INFORMATION BULLETIN

PLINKER'S CANYON

Regarding: Conversion of coin lockout PCB Assy.

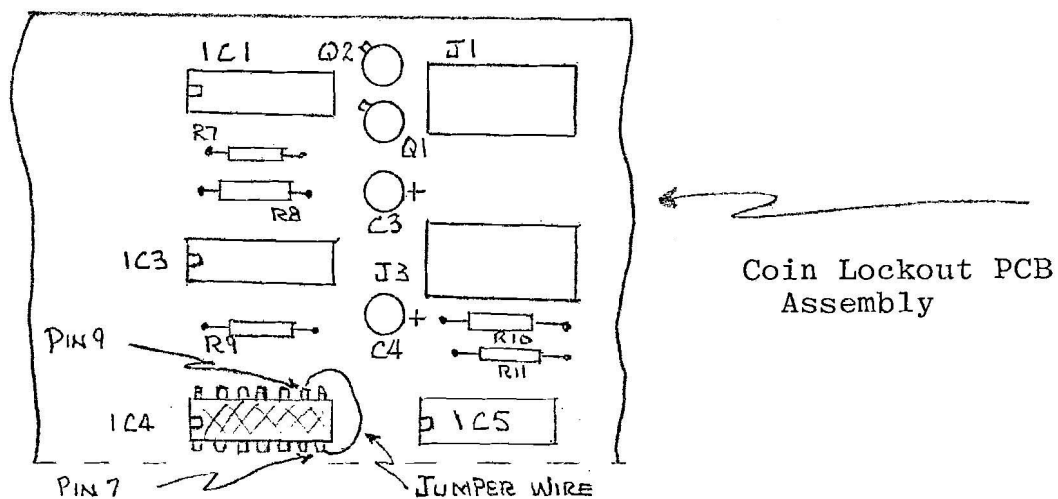
1. Remove A.C. power before proceeding with conversion.
Remove the coin lockout PCB assembly 260031 from the gun cabinet and add a jumper wire from IC4 pin 9 to IC4 pin 7 using a pencil soldering iron of not more than 25 watts to prevent damage to the I.C. Refer to sketch.
